**MONTGOMERY COUNTY HISTORIC PRESERVATION COMMISSION**  
**STAFF REPORT**

<b>Address:</b>	7209 MacArthur Blvd., Bethesda	<b>Meeting Date:</b>	12/7/2022
<b>Resource:</b>	Contributing Resource <b>Potomac Overlook Historic District</b>	<b>Report Date:</b>	11/30/2022
<b>Applicant:</b>	Kim & Arthur Newmyer (Robert Black, Architect)	<b>Public Notice:</b>	11/23/2022
<b>Review:</b>	HAWP	<b>Staff:</b>	Dan Bruechert
<b>Permit No.:</b>	1008960	<b>Tax Credit:</b>	Partial
<b>Proposal:</b>	Partial demolition and construction of a new rear addition, hardscape alteration, and fenestration alterations.

## Response to Historic Preservation Commission Preliminary Consultation Report

Re: 7209 MacArthur Blvd, Bethesda, MD

3 HEAD DETAIL  
A300 3"=1'-0"

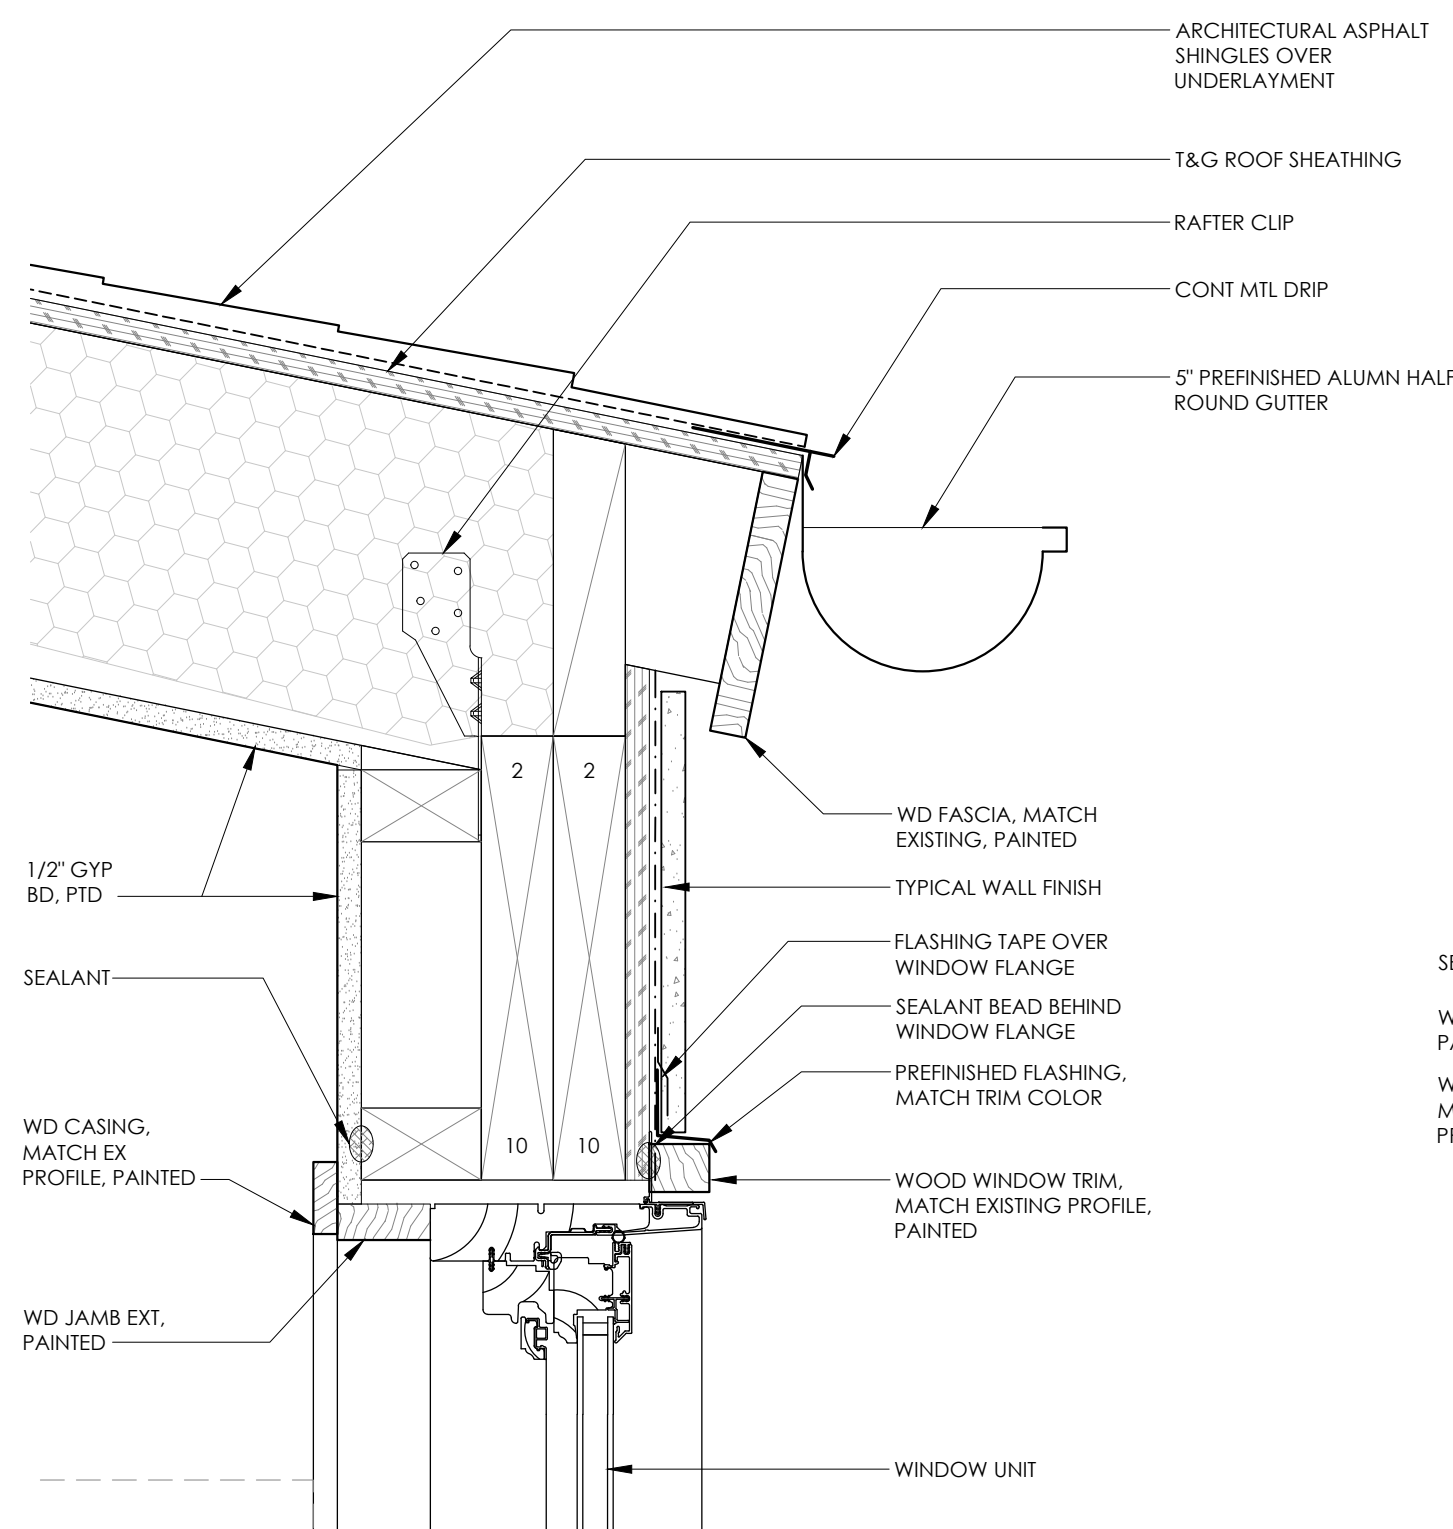
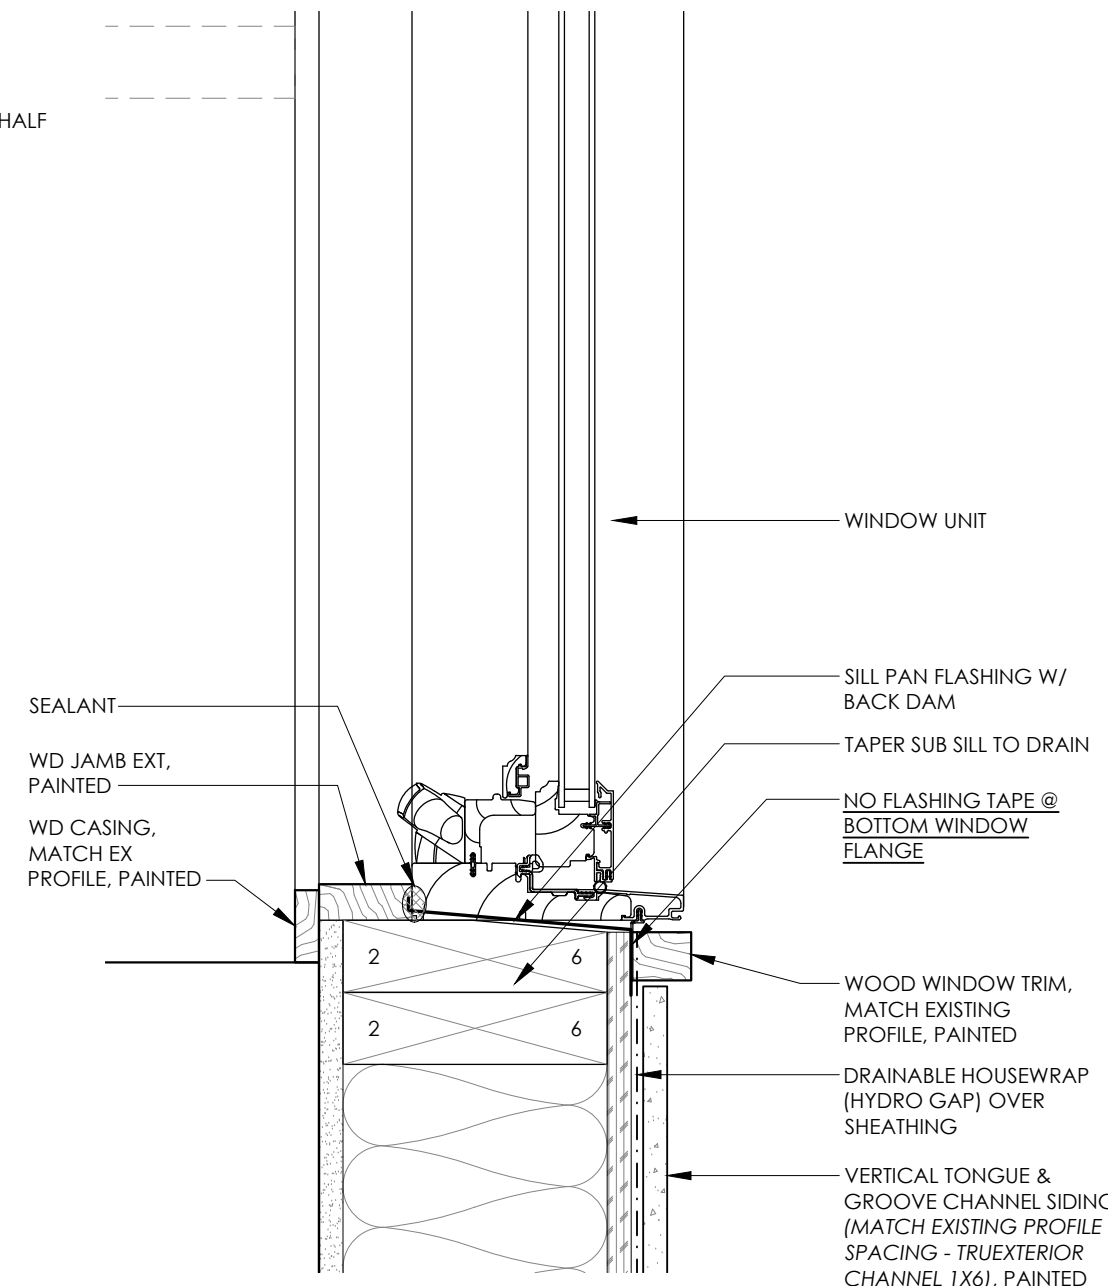
- **Comment:** *Windows must be appropriately detailed – window specifications need to be included in the HAWP application.*

**Response:** All proposed window and door trim will match the existing profile using painted wood. See details on drawing A200, wall details on A300 and A800 for sections of window units.

**AWNING WINDOW DETAIL**

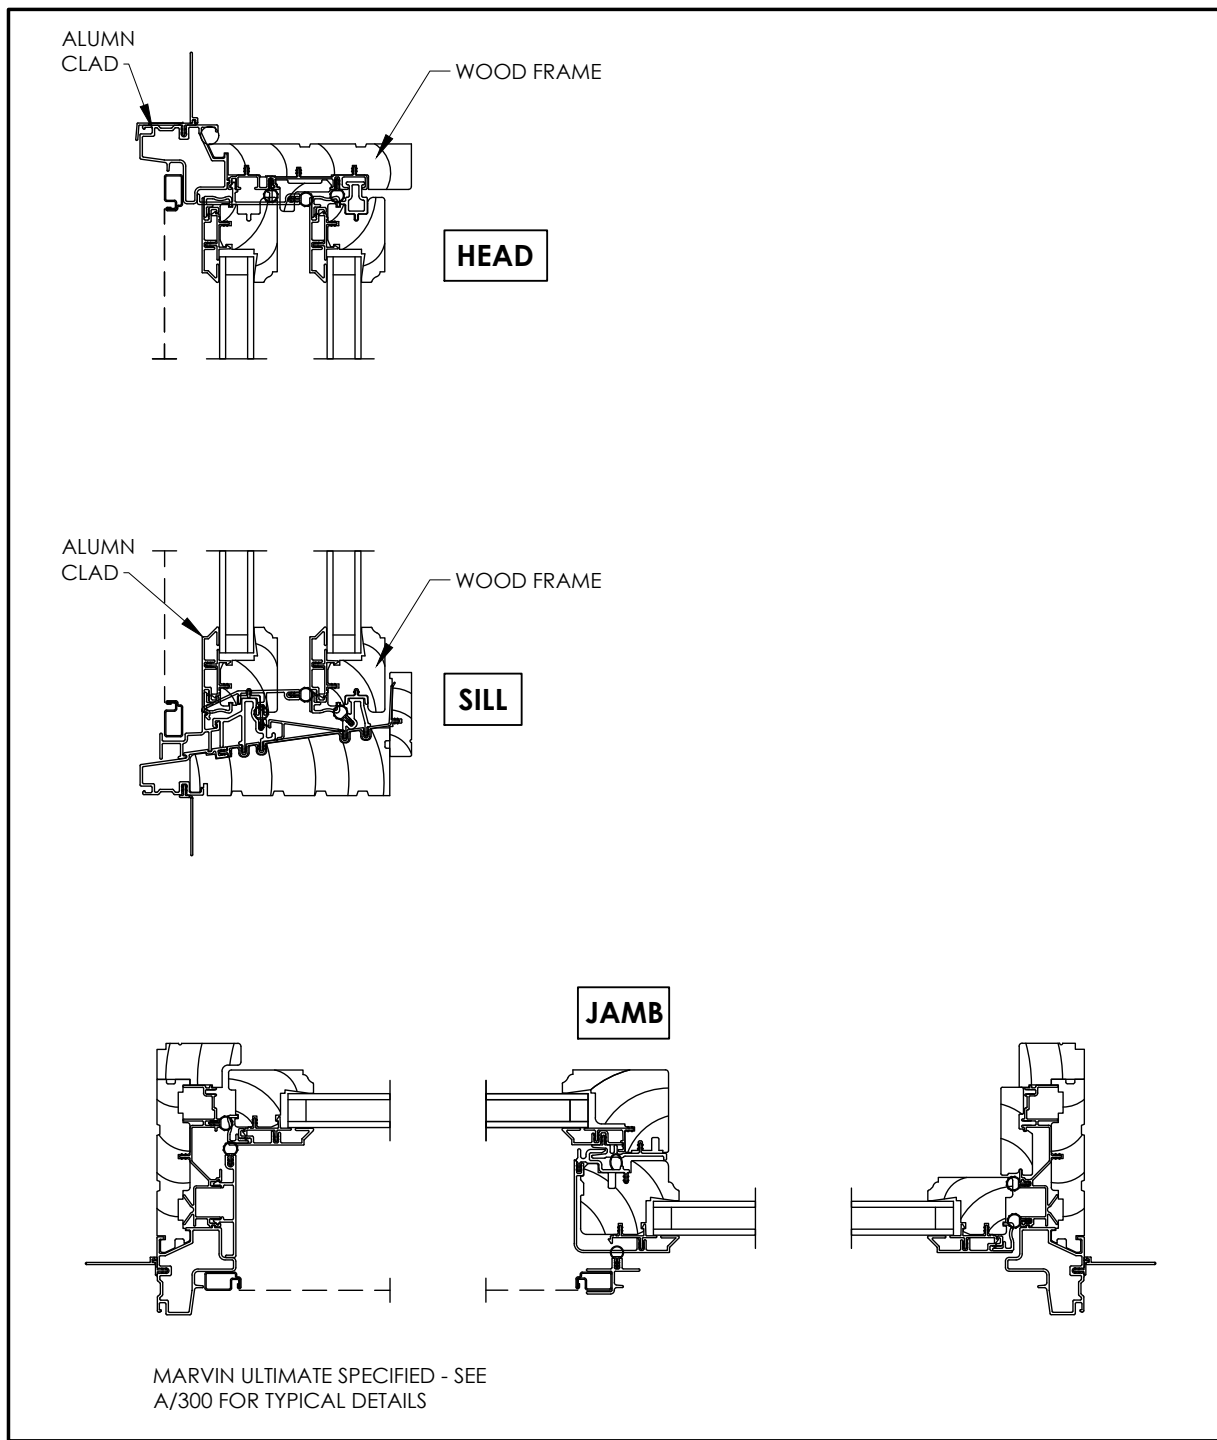
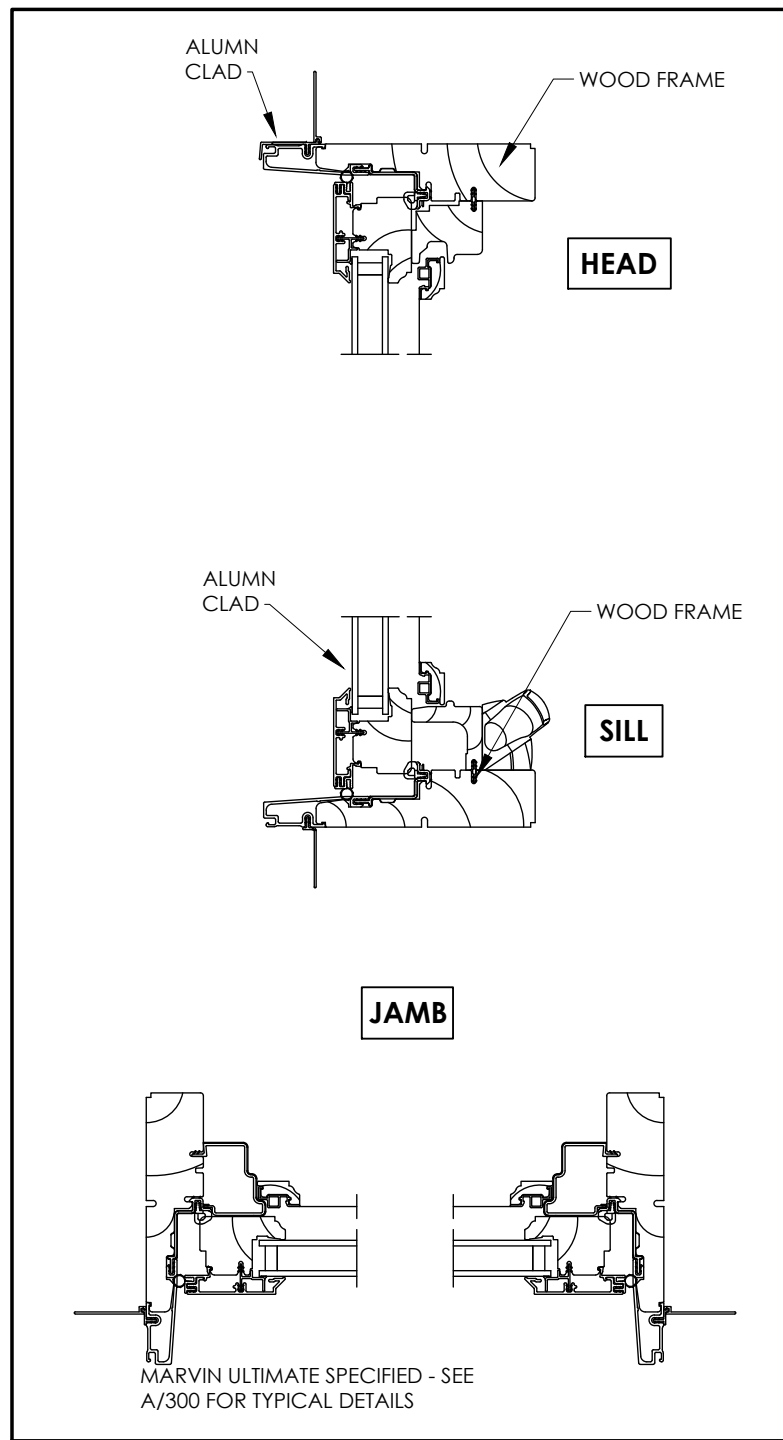
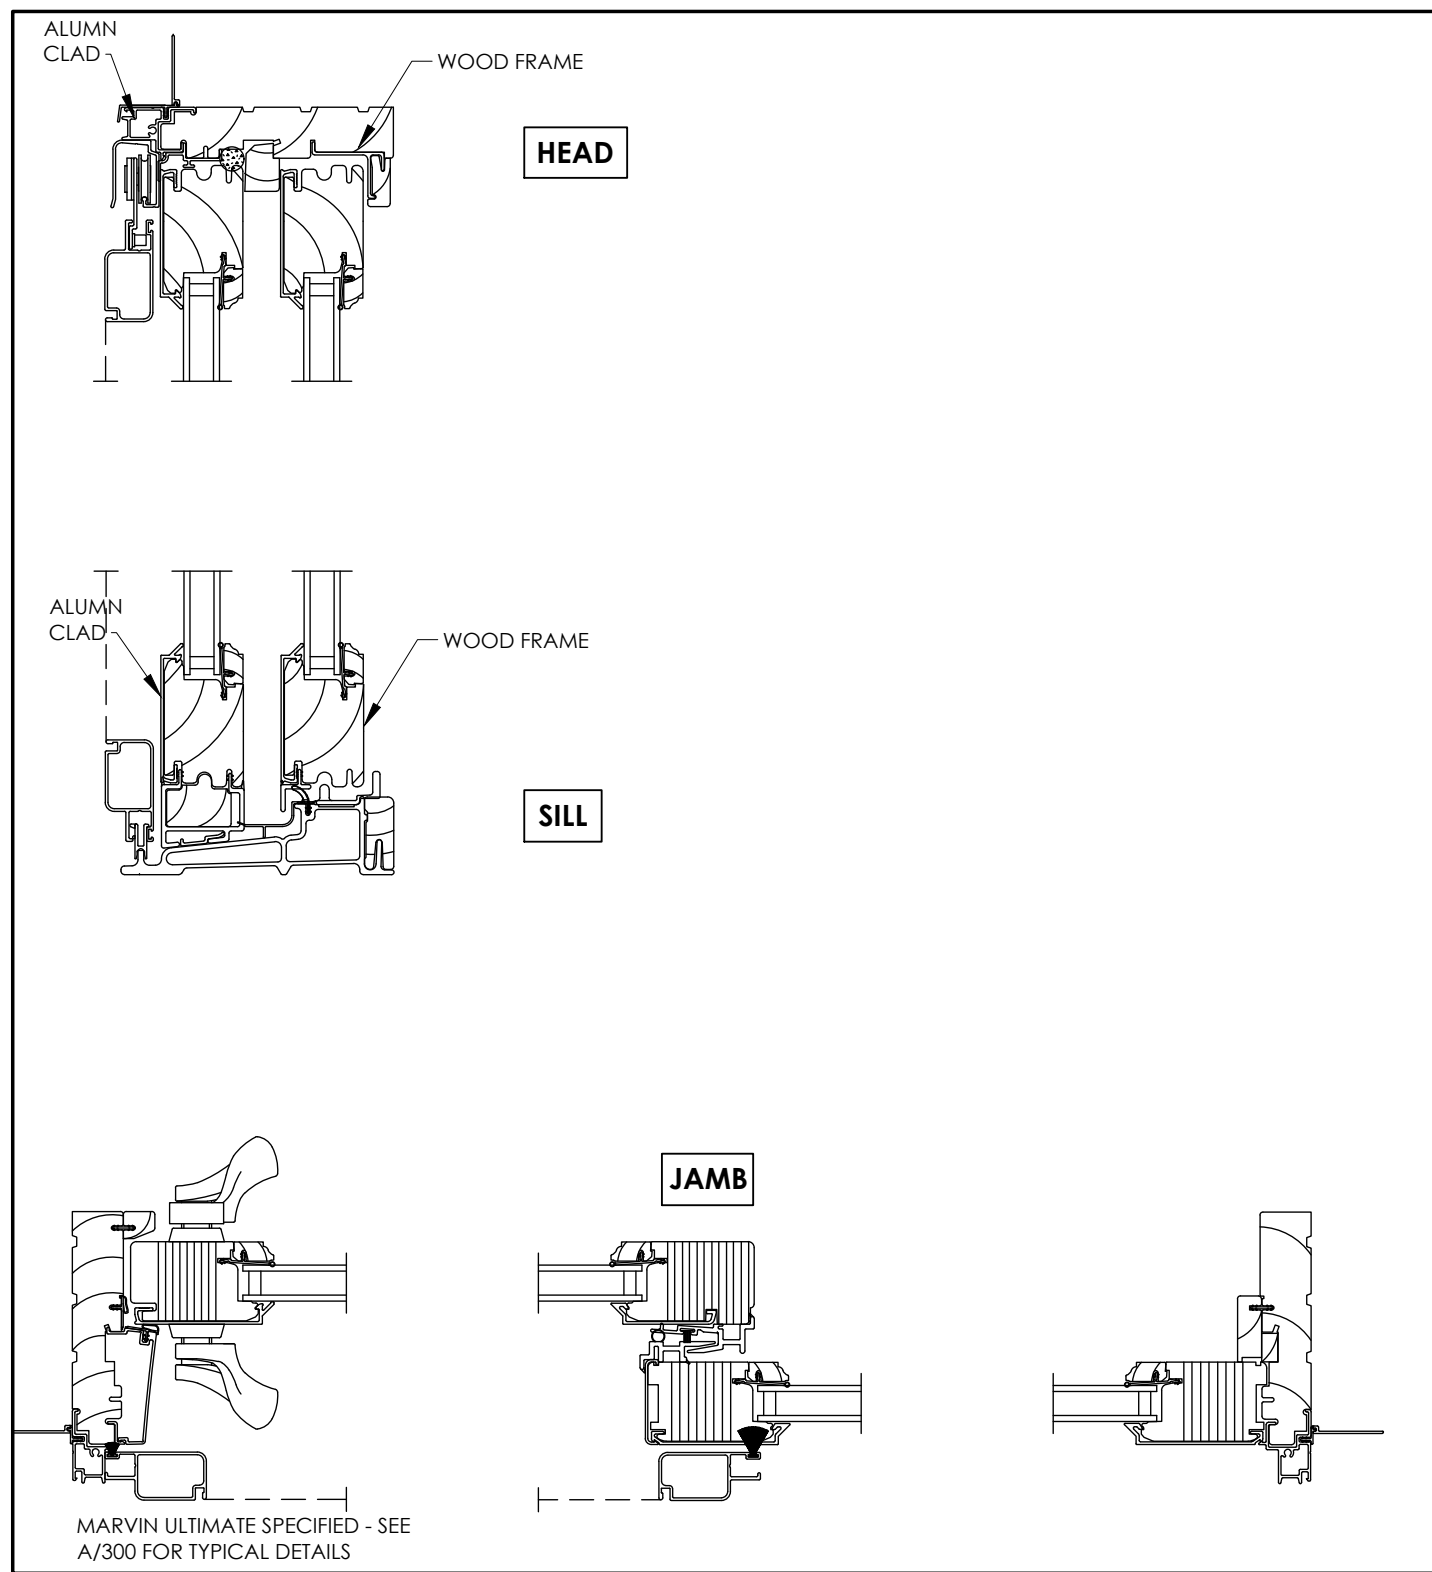
- **Comment:** *Several Commissioners supported re-sizing the new rear windows, so they had a consistent configuration instead of introducing two new sizes/configuration of windows.*

**Response:** The proposed rear fenestration pattern has been revised to replicate the existing pattern (See drawings A200, A201, A203, A300). The proposed windows are Marvin Ultimate aluminum clad wood framed awning windows (A800 shows section details of units proposed). The unit size is similar in width, height and the sills align. Placement is approximate to the existing. The vinyl window to the left of the proposed sliding glass door is being replaced with a Marvin Ultimate aluminum clad glider type unit. The size matches the original historical units.

**Response:** All proposed windows are the same unit size for a consistent elevation.
